Development Plan Review, Site Plan Review, Conditional Use

15-018DP-BSD/SP-BSD/CU – Bridge Park Phase 1

Mixed-Use Development – Riverside Drive and Dale Drive

Development Plan Area

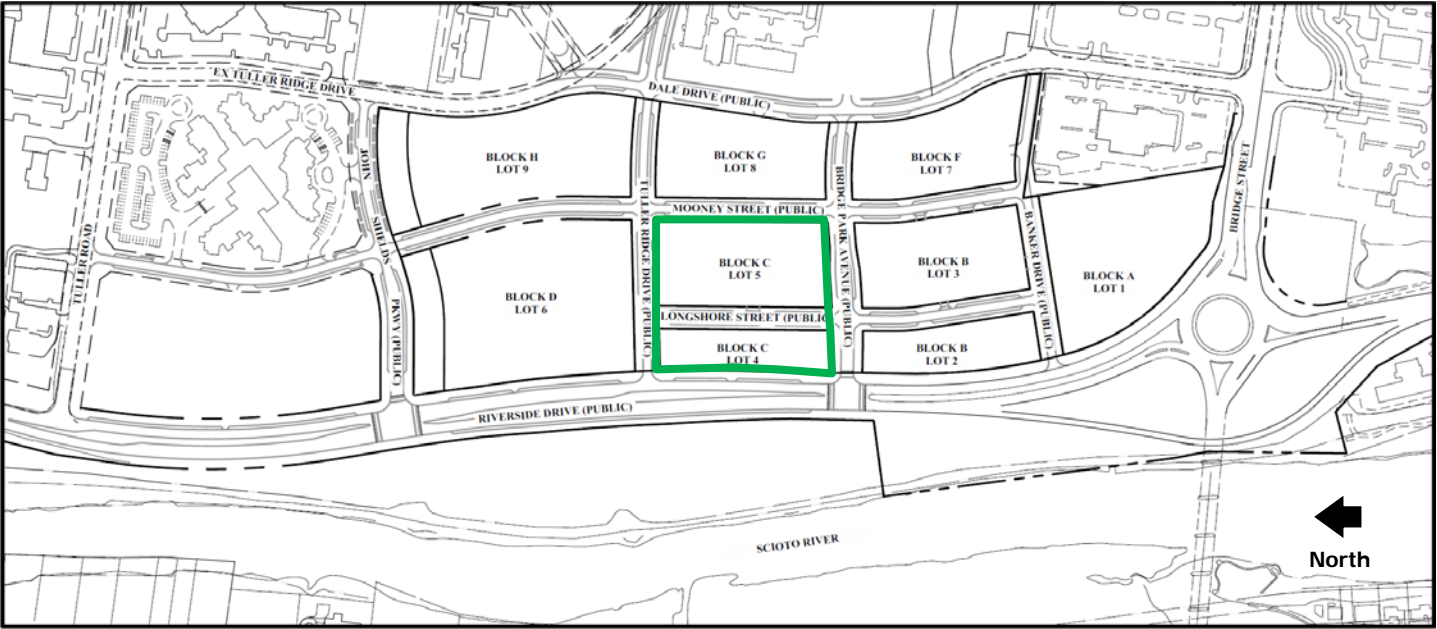
The proposed Development Plan for this initial phase of development includes:

- A grid street network consistent with the approved Basic Development Plan;
- Segments of four new public streets (Bridge Park Avenue, Tuller Ridge Drive, portions of Mooney
